SERVICE BULLETIN

APPLICABILITY: 2014-2016MY Crosstrek Hybrid (HEV) Models **NUMBER:** 11-180-18
SUBJECT: DTCs P0A78 and P1C2A- ECM Reprogramming **DATE:** 05/30/18
 File Availability

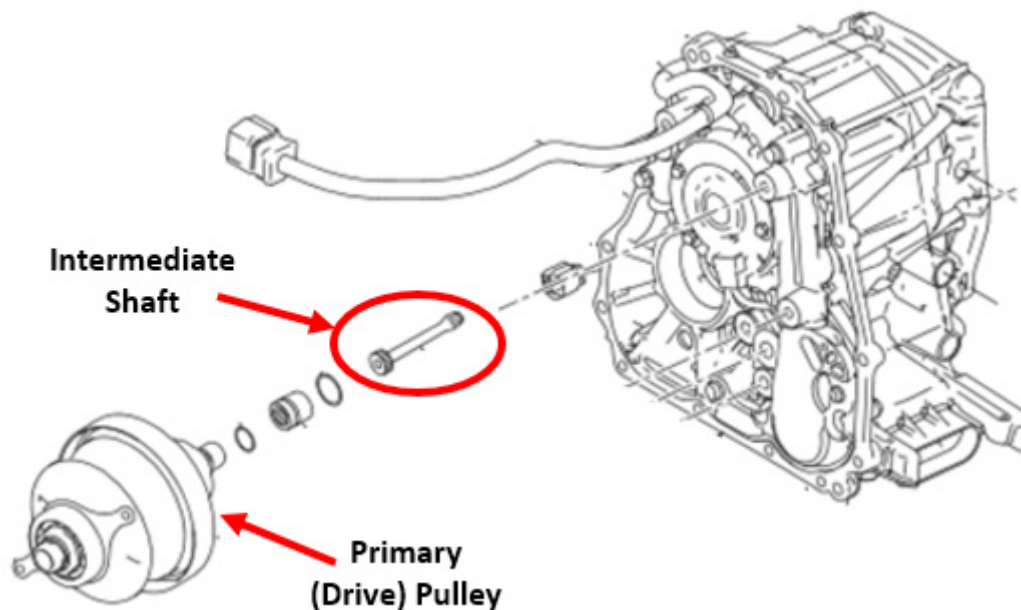
In the event of a Drive Motor and / or Inverter malfunction, DTC P0A78 **AND** P1C2A may set at the same time. This is a RARE occurrence. As a result, the drive motor could be supplied with a higher than specified level of current and damage (twist from over-torque) the CVT's Intermediate Shaft (see below) which is located inside the primary (drive) pulley.

VERY IMPORTANT: In the unlikely event DTC P0A78 **AND** P1C2A are detected and set at the same time, follow the diagnostic procedures for BOTH DTCs to determine the fault **BEFORE** proceeding with reprogramming the ECM. In this case, the following 4 components must be replaced together **as a set** following the procedures supplied in the applicable Service Manual.

- Drive Motor Control Module (DMCM)
- Inverter Assembly
- Inverter wiring harness (between the DMCM and the Inverter)
- CVT Intermediate Shaft.
